7 July 2026

Staff Submission	Response to Submissions
Application Number	SSD-97528708
Proposal	Mixed used development with in-fill affordable housing
Location	13 Gipps Street, 6 Shadforth Street and 142-148, 160 Oxford Street, Paddington

Figure 1: Graph showing growth in dwelling sizes, 2011-2021

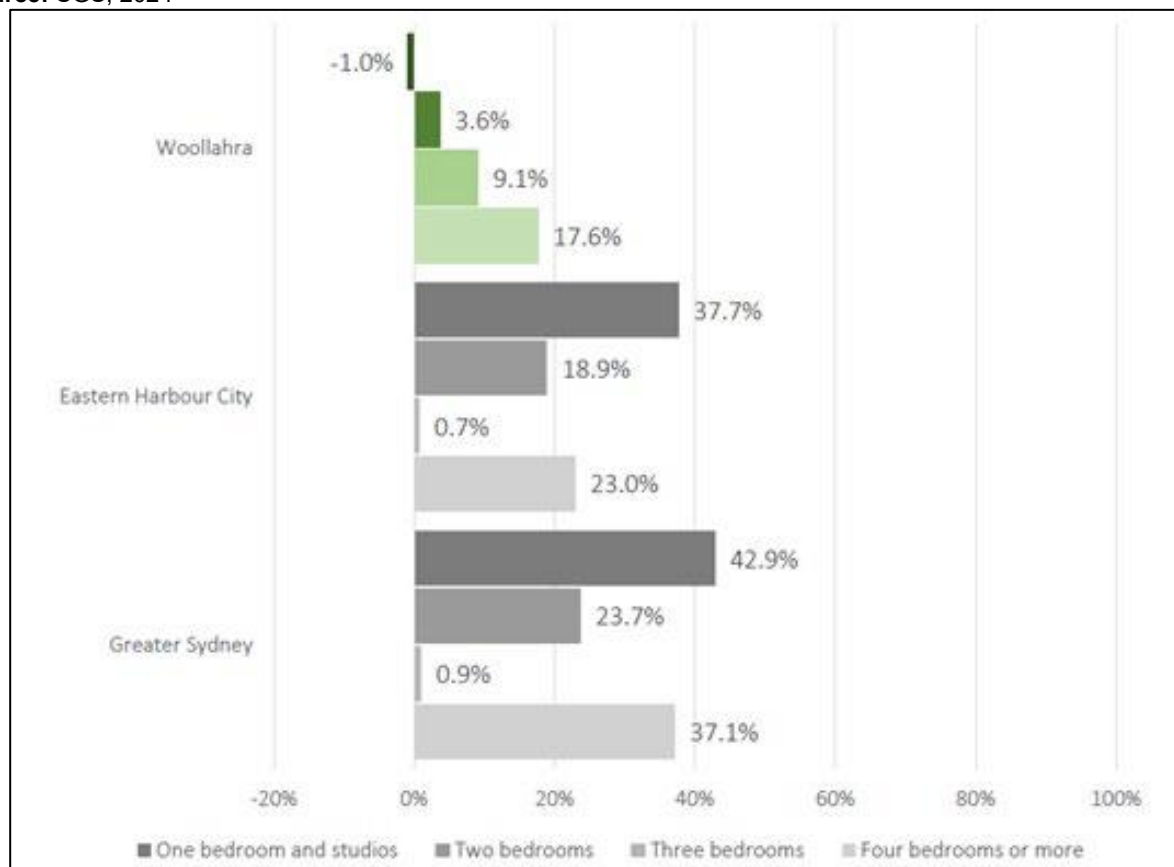
- This trend has contributed to a short supply of smaller, more affordable dwellings.
- According to the 2021 ABS Census, only 12.5% of dwellings in Woollahra LGA are studios or one-bedroom apartments. Over the last decade, this typology saw rapid growth across the Eastern Harbour City and Greater Sydney (38% and 43% increases, respectively). In contrast, Woollahra saw a 1% decline in one-bedroom and studio dwellings, while larger homes, particularly four-bedroom houses, grew by 18% (see Figure 1).

- The SSDA fails to provide a dwelling mix that meets the needs of a diverse population.
- The proposal should be amended to deliver a meaningful contribution to housing supply, particularly smaller dwelling types, rather than consolidating development potential into a limited number of large, high-end apartments. Staff recommend that the proposal shall be revised to require at least 30% of new

dwellings (rounded to the nearest whole number) to be self-contained studio or one bedroom apartments, or a mix of both.

Figure 2: Shadforth Street elevation showing additional bulk from planters

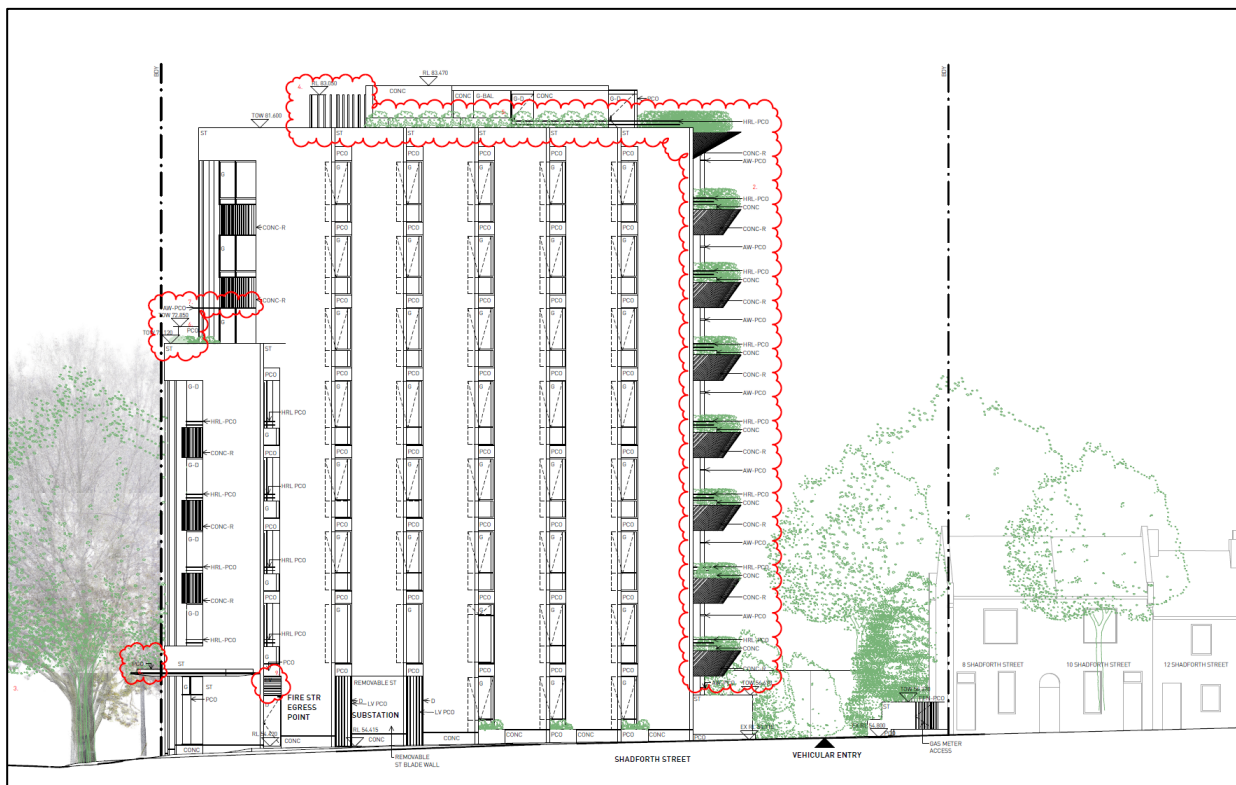
The amended proposal has not increased the setback in accordance with the ADG, instead planters have been added to the originally proposed building envelope at levels L1 to L7 and the originally proposed northern planter to the roof terrace has been extended further to the north. At the closest point the northern planters are only setback approximately 7.6m from the northern boundary to the terrace properties to the north.

The proposed planters add additional bulk to a building that already dominates the locality and the immediately adjoining low density residential properties to the north.

It is noted that the 12 x 3 bedroom units located at the three upper levels of the building are over twice the ADG required apartment size, therefore the upper levels of the building could be brought into compliance with the ADG separation requirements without a reduction in proposed dwellings.

Figure 5: Swept Turning Circles
Source: CTMP

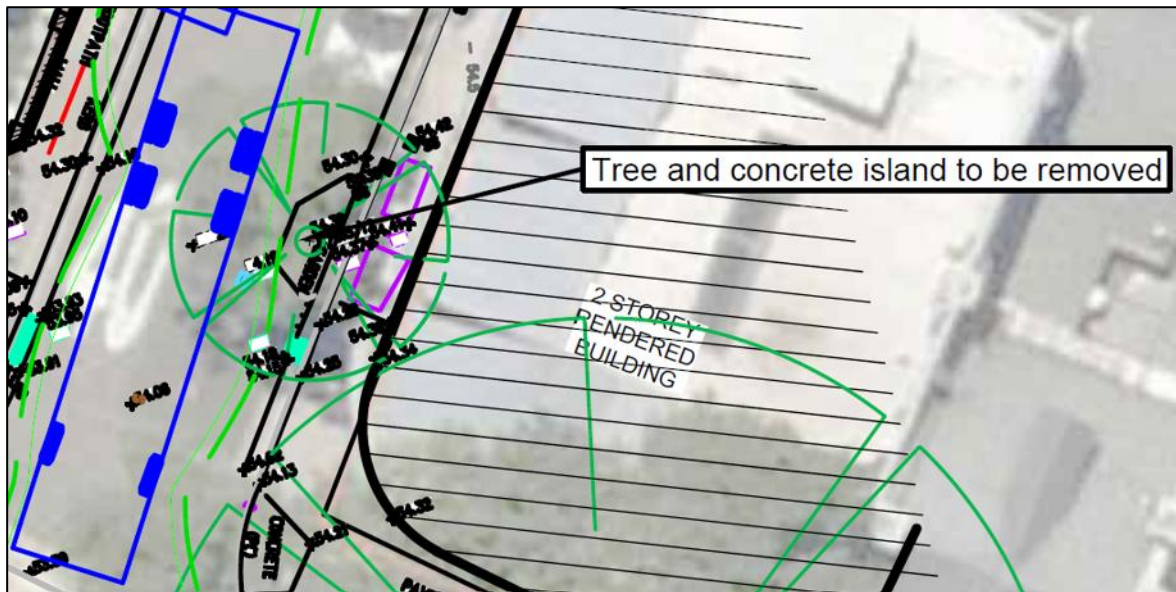
The Swept Turning Paths diagrams in the CTMP show the tree pit located marginally on the edge of the tree's pit, however, the documentation does not provide sufficient information to demonstrate the need to remove the tree and the pit structure, for the temporary access needs.

In the absence of this information and the lack of alternatives presented, Council's preference remains the retention of Tree 18.

Figure 6: Specification for In Road Planting (With Kerb)

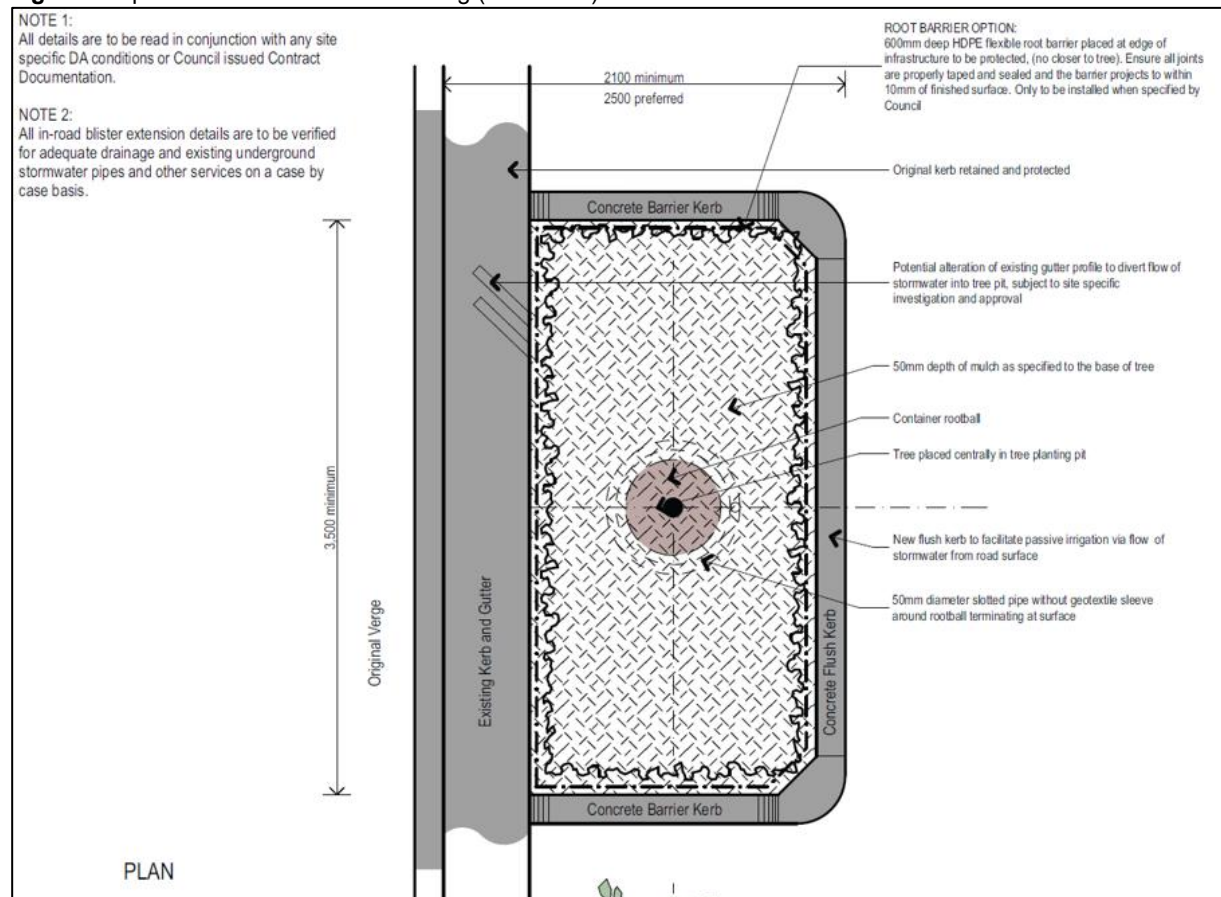
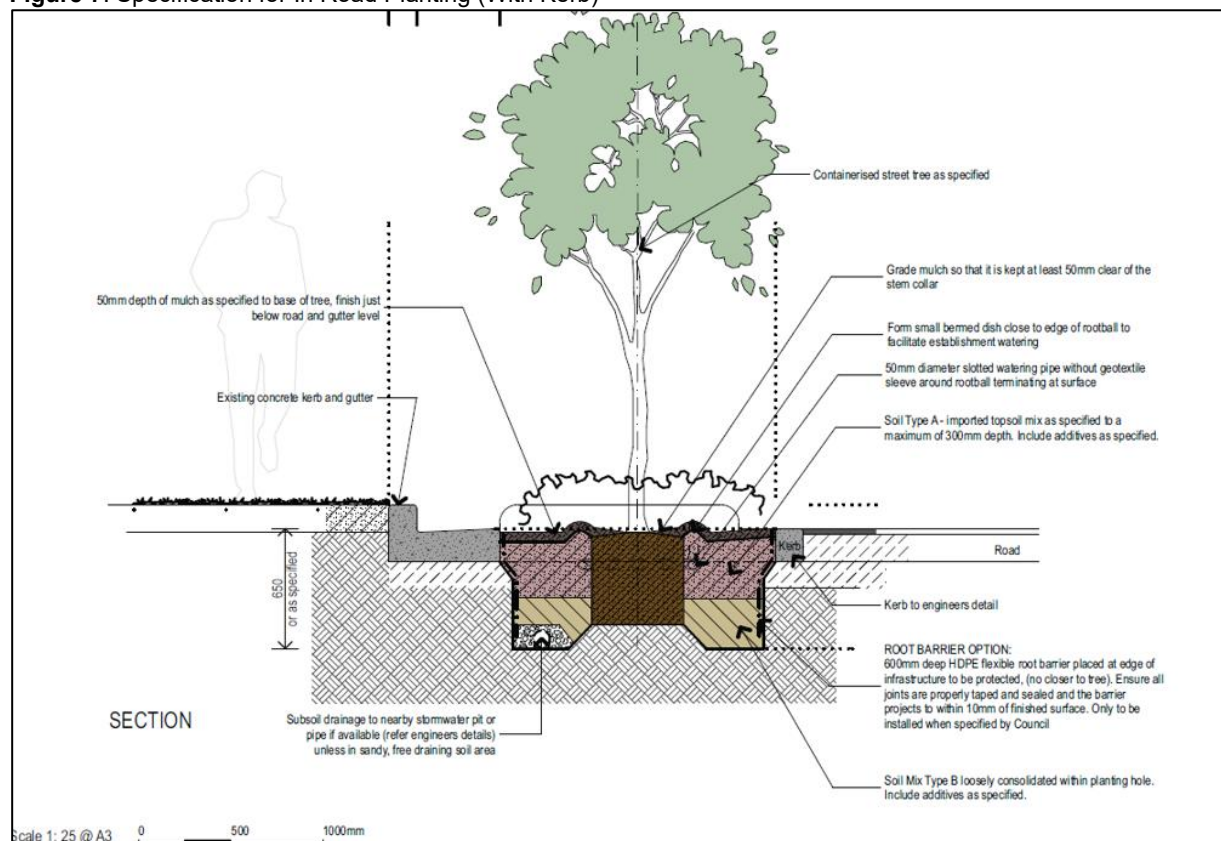
An amended landscape plan prepared in accordance with Council's DA Guide including:

- Replacement of Tree 18 with a 200litre replacement tree, of a species in accordance with Woollahra Council Street Tree Master Plan (i.e. *Pyrus ussuriensis* -Manchurian Pear, or *Pyrus calleryana* 'Chanticleer').
- The Landscape Plan shall include the below specifications for In Road Planting with Kerb (or similar technology) and demonstrate that tree replanting is achievable with the existing below grade conditions and services.
